Source: Leece-Neville Heavy Duty Systems Division – Arcade, NY

Bulletin No: TSB-1194 (Hungarian) **Date:** November 5, 2021

Models: 8MR

Subject: 8MR to A1743D and A1744H

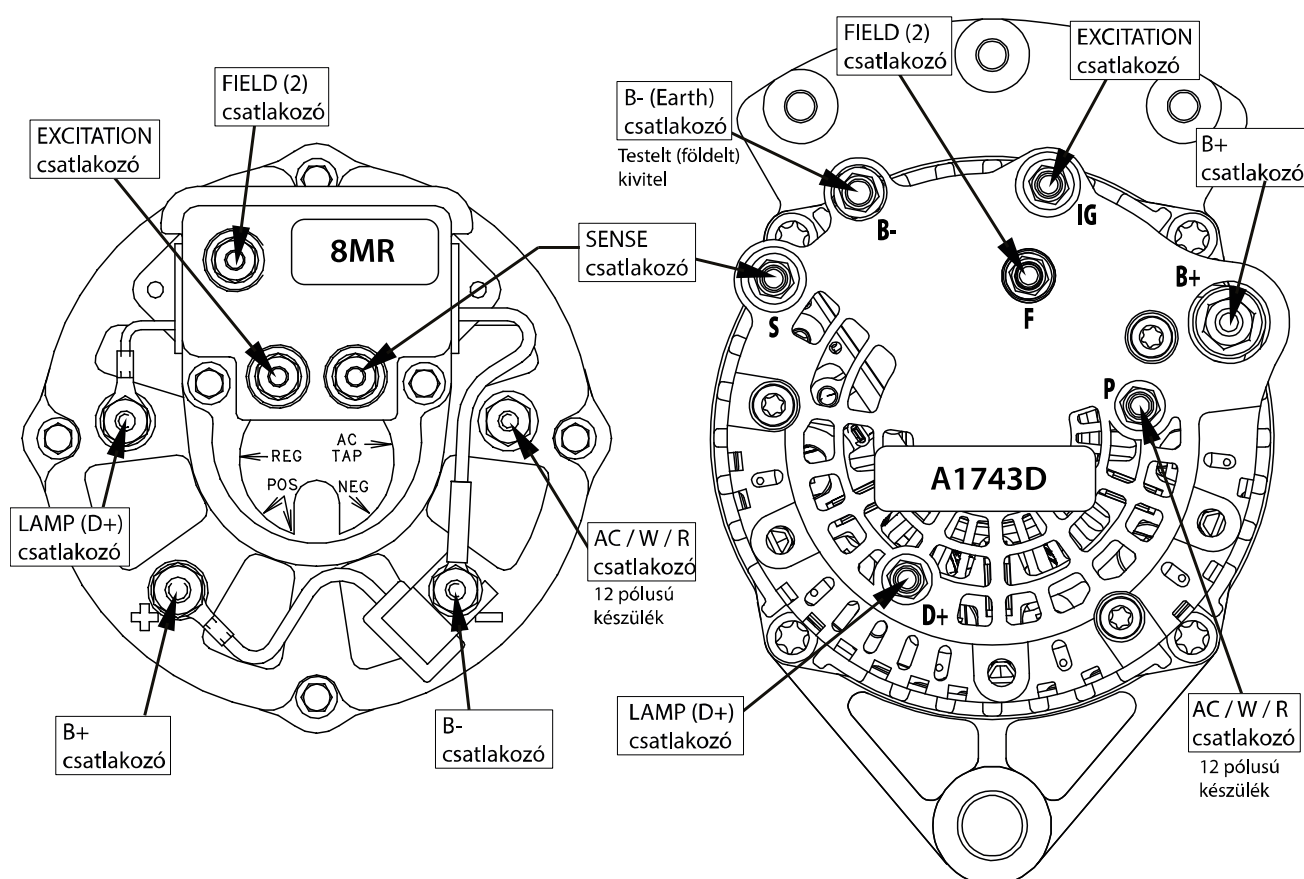
A 8MR generátor megszünt, és az A1743D (105A) valamint az A1744H (70A) váltja fel.

Ezek a generátorok csereszabatosak a 8MR-el, de ezek földelt (testelt) készülékek, míg a 8MR szigetelt volt.

Megjegyzés: Az A1743D és az A1744H belső hűtőventilátorral rendelkezik, ne szerelje fel rájuk a 8MR külső ventilátorát.

Ez a dokumentum segít azonosítani a különféle terminálkivezetéseket.
Az A1743D és A1744H részletes kapcsolási rajzát lásd a TWB-0054 dokumentumon.
